DS-K1T680 Series MinMoe Terminal Release Note (2026-3-25)

<p>Device Model: DS-K1T680D(F)-E1 DS-K1T680D(F)W DS-K1T680D(F)G DS-K1T680D(F)G1</p>	<p>Firmware Version</p>	<p>ARM: ACS_680_AI3_EN_NEU_V3.7.80_buil d251218 ACS_680_AI3_EN_STD_V3.7.80_build 251218</p>
<p>Modules (optional): DS-KAB6-D1 DS-KAB6-W1 DS-KAB6-ZU1</p> <p>Naming Rule: D for M1 card, Desfire card, Felica card E1 for POE, W for Wi-Fi, F for fingerprint G1 for 3/4G, supported in Australia, Taiwan (China) and Latin America; G for 3/4G, supported in Europe, the Middle East, Africa, India, and Most Areas of Asia-Pacific (excluding Japan and Taiwan (China))</p>	<p>Platform Version</p>	<p>HikCentral AC: https://www.hikvision.com/en/support/download/software/hikcentral-access-control-v2-4-0/</p>

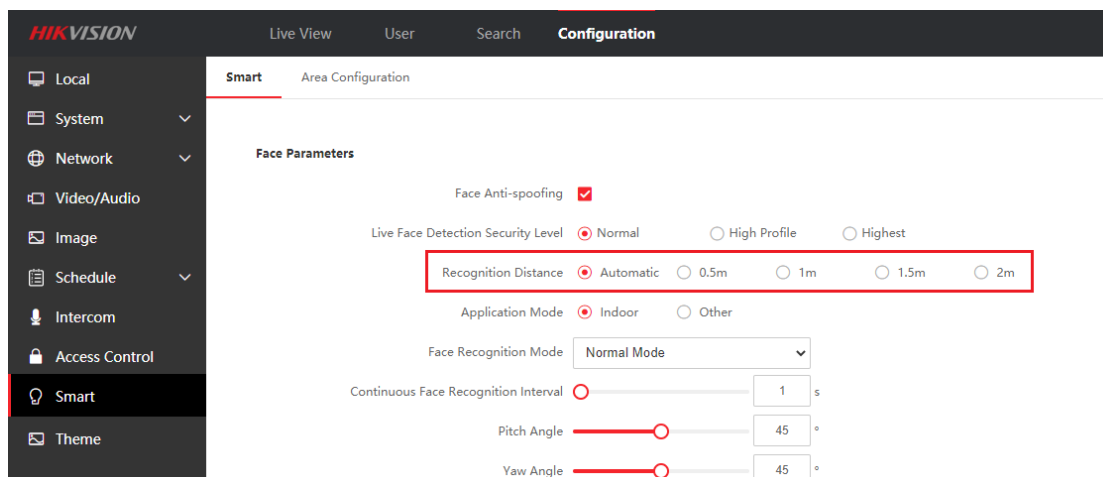
1. Add Hik-Connect menu in device UI Menu → Comm. The function is disabled in default.

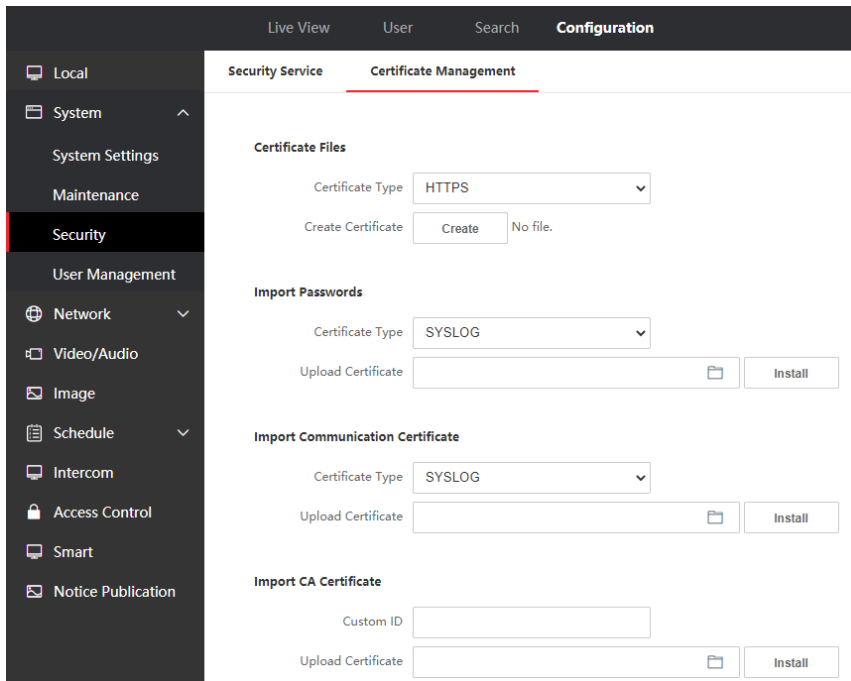
1. Support https feature

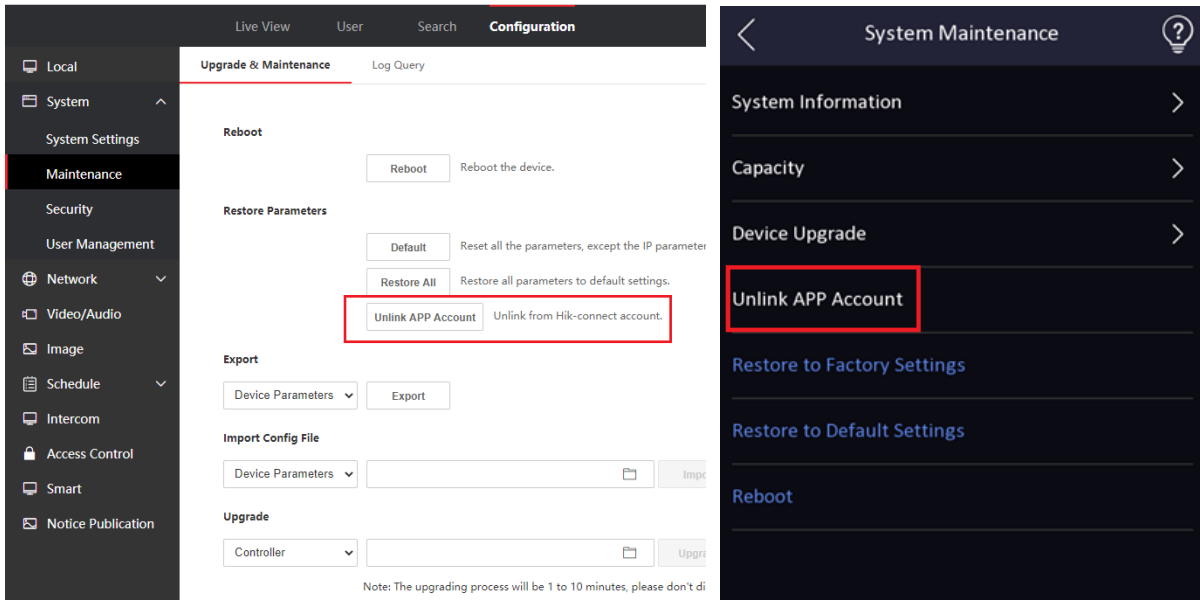
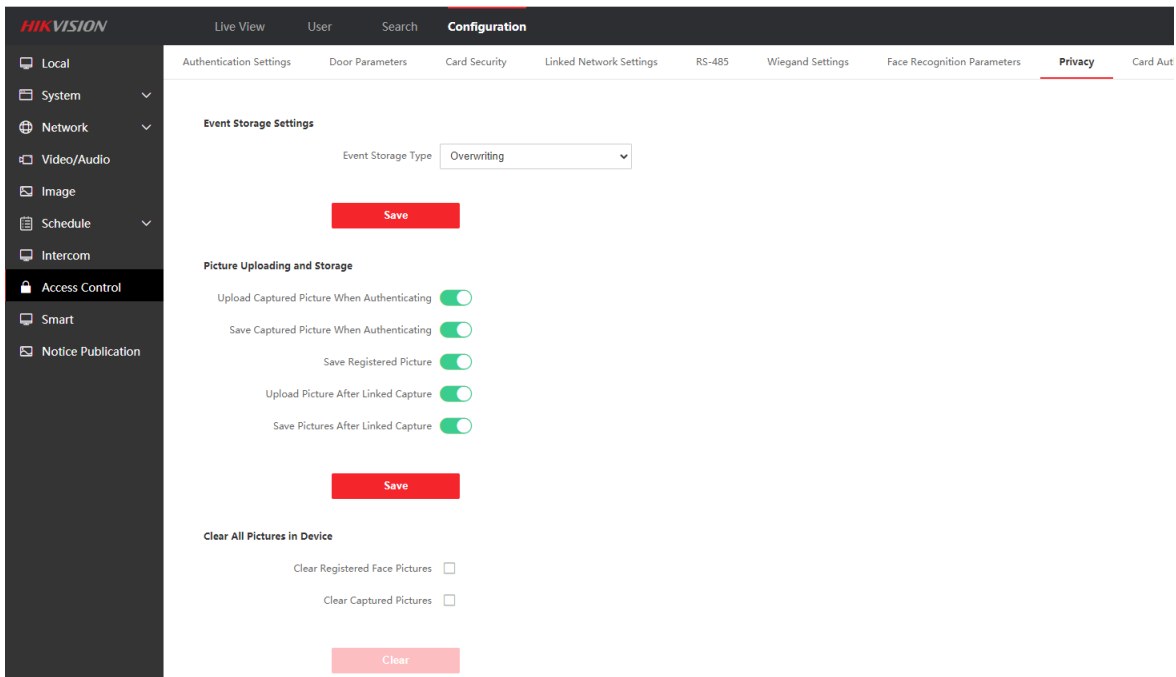
6. Support unbind device with hik-connect account on SADP tool, local UI and web

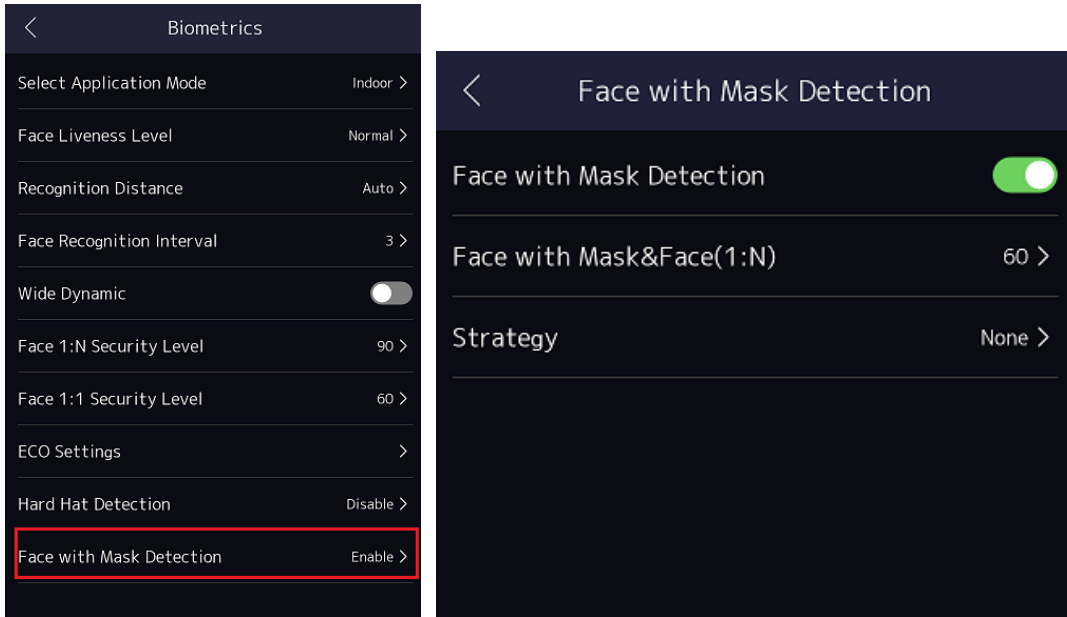
7. Add privacy protection, support event Storage Settings, Picture Uploading and Storage, Clear All Pictures in Device

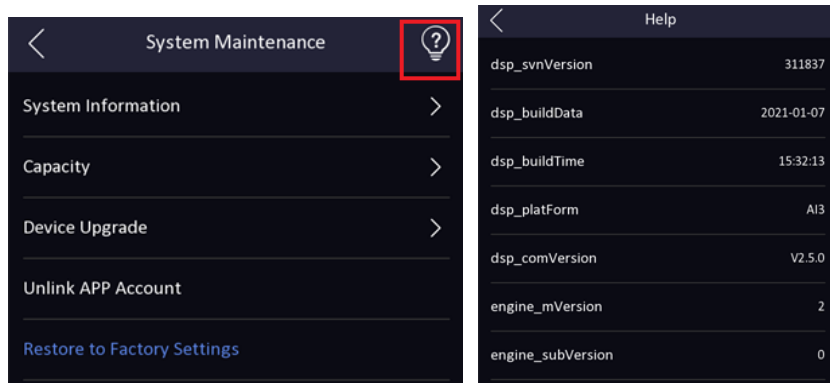
8. Add face mask detection function(enabled in default);

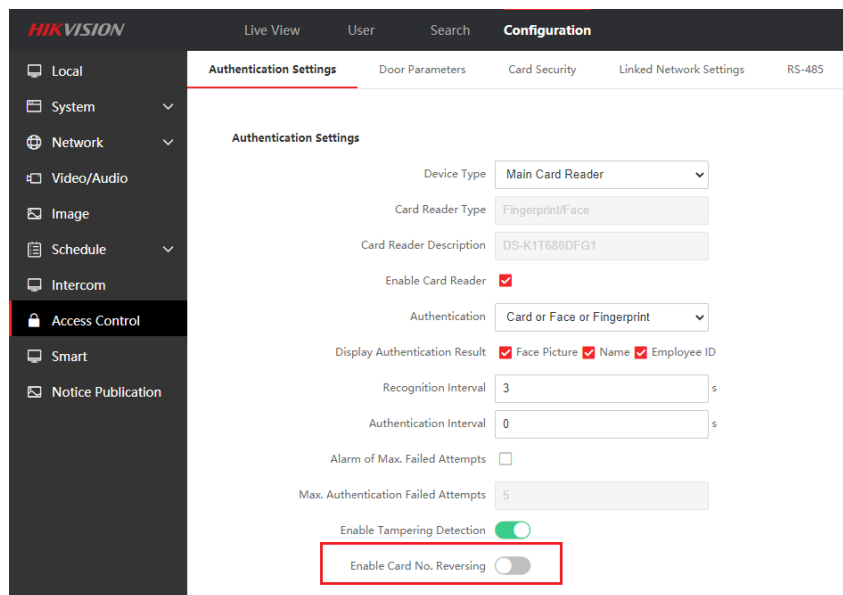
9. Add help interface to check system module version for technical support (long press for 3s).

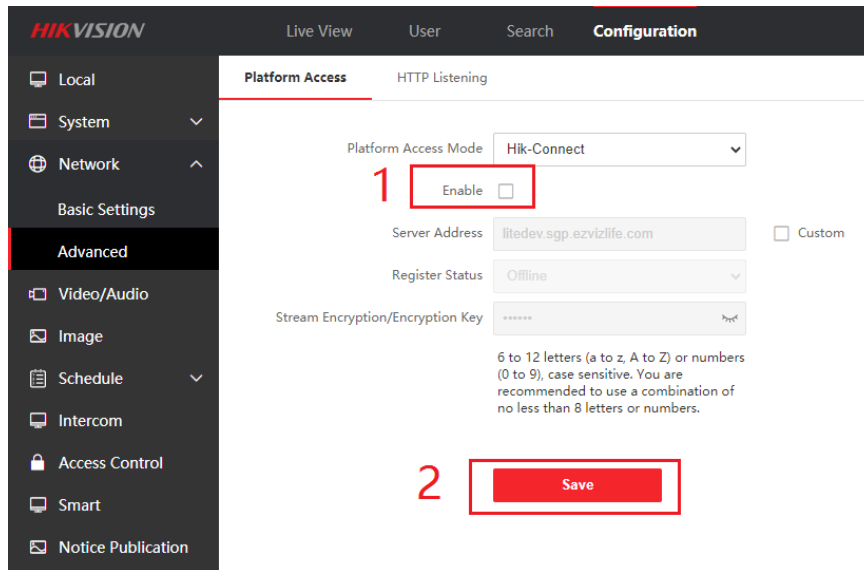
10. Add card No. reversing function (external reader not support)

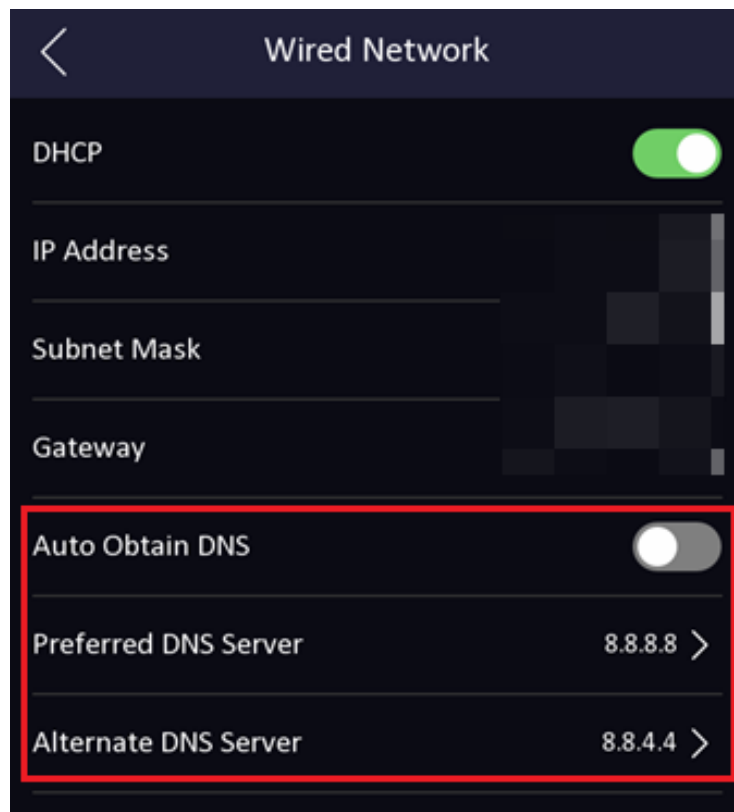
4. Hik-Connect function is turned off in default for privacy protection, if customer want to manage device from App, please turn on manually in the web.

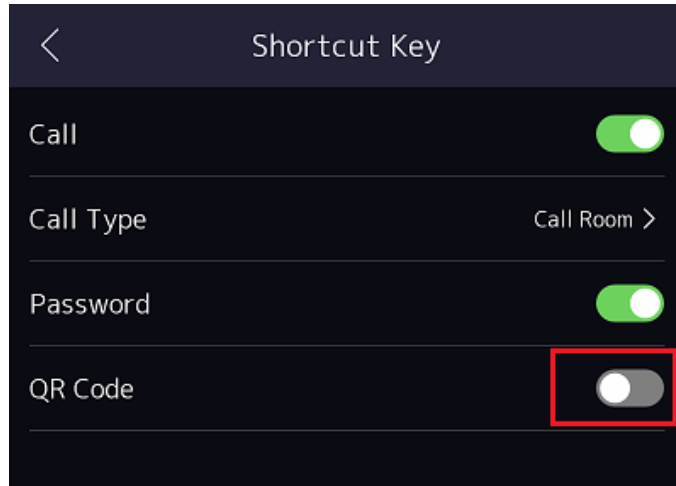
5. DNS can be configured from device UI in menu → Comm.-->Wired Network

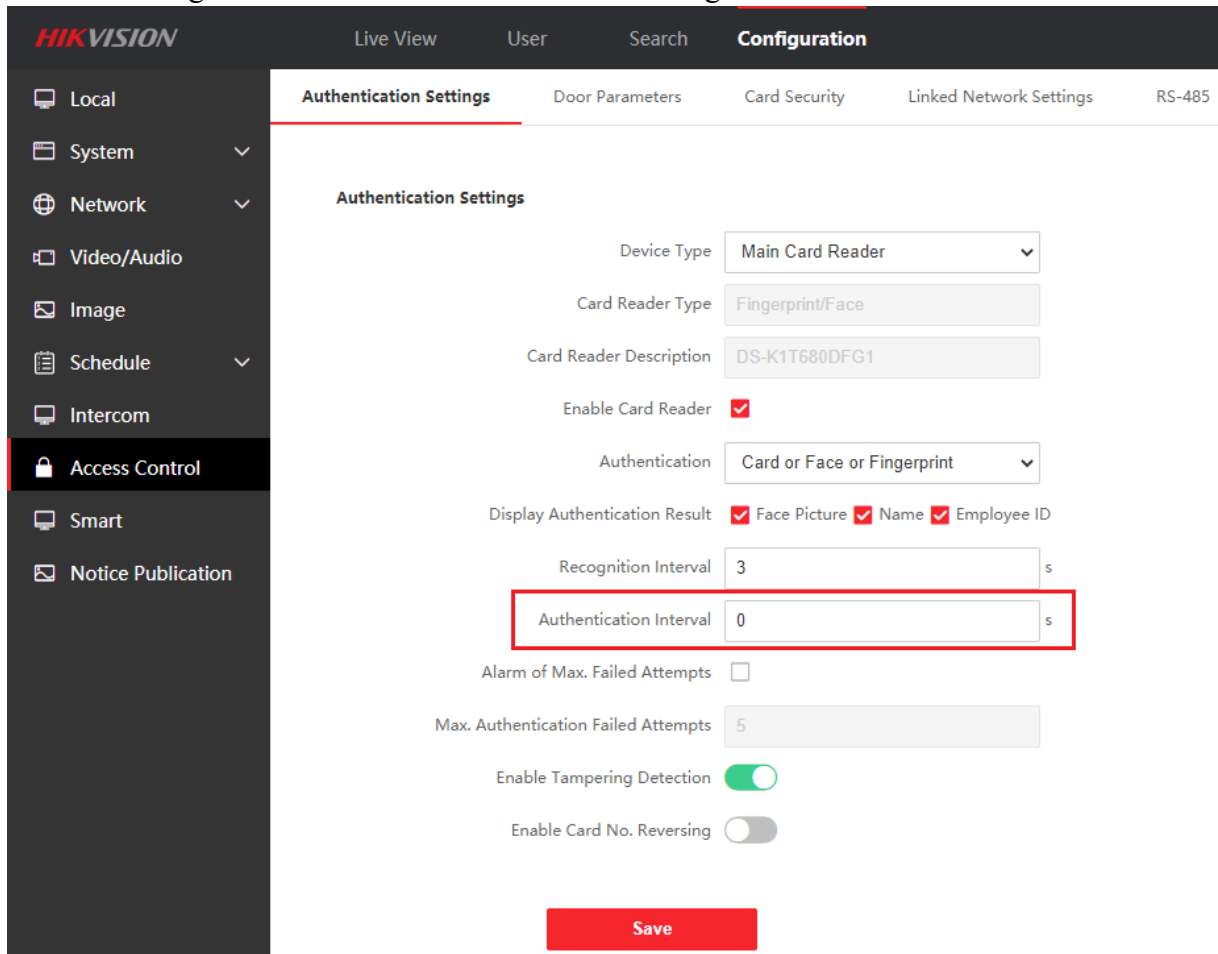
6. After disable QR code shortcut from the menu, device will support QR code and face verification at the same time.
